Joint Meeting of the RID Committee of Experts and the
Working Party on the Transport of Dangerous Goods

Consolidated comments by Members of the Joint Meeting on draft standards dispatched by CEN since the last session

Transmitted by the European Committee for Standardisation (CEN)

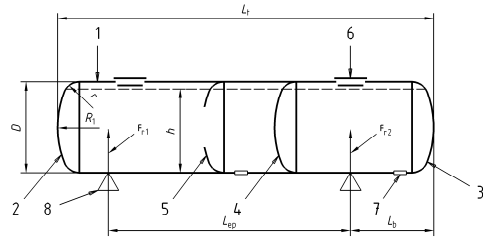
EN 13094:2008 +AC:2008	Tanks for the transport of dangerous goods - Metallic tanks with a working pressure not exceeding 0,5 bar - Design and construction	Where to refer in RID/ADR: 6.8.2.6	Applicable sub-sections and paragraphs: 6.8.2.1		
Correction of Figure A.1 Main tank characteristics (not relevant to the German issue.)					
Comments from members of the Joint Meeting:					
Country	Clause No.	Comment (justification for change)	Proposed change	Comment from CEN Consultant	Comment from WG Standards
CEN	A.5.2.1, Figure A.1 Main tank characteristics	Existing figure in EN 13094:2008  Replacement in EN 13094+AC:2008:  		Indispensable for understanding of the characteristics of a tank shell, subject to calculation.	The WG realizes that the corrigendum AC:2008 to EN 13094:2008 is correct in all details and should be referred to in ADR 2011 as a replacement of EN 13094:2008 without any transition regulation - see proposed amendment in separate report of the Std's WG, September 2009 The WG is aware of the fact that the drawing dispatched by CEN was faulty and the UK comments are not relevant, therefore.

UK	Figure A.1	As a replacement for the current Figure A.1, it is a great improvement. However, (a) the symbols do not match Table A.1 (see row below) and (b) there is no key for the numbers in the figure.		To be considered for the edited version for printing.	
UK		Figure A.1 L B Ep R1 R2 R	Table A1 L _t L _b L _{ep} F _{r1} F _{r2} R ₁		
Decision of the STD's WG:		Accepted Refused Postponed	Comments
